From: <Doddv@~~XXXX~~> *C. Dodd*  
To: <WLS@nrc.gov> *W Schmidt*  
Date: Mon, Jul 17, 2000 2:45 PM  
Subject: IP2 tubes with signals in 1997

Here are the final two tubes with defects present in 1997. With a diligent inspection, and by using circumferential average filtering, these defects are visible on the C-scan.

**Figure 1** Tube 2-71 of SG24 in 1997 at 400 kHz, with circular average filter applied.

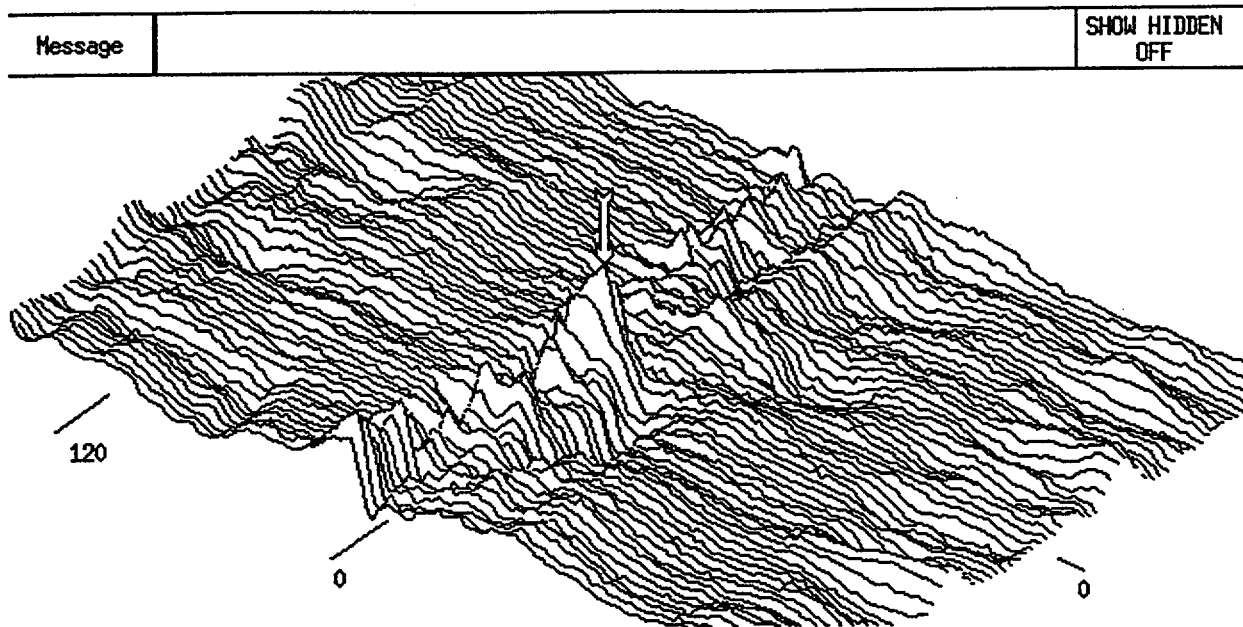
scan. Tube 2-71 and 2-85 need the circular average filter applied for detection.
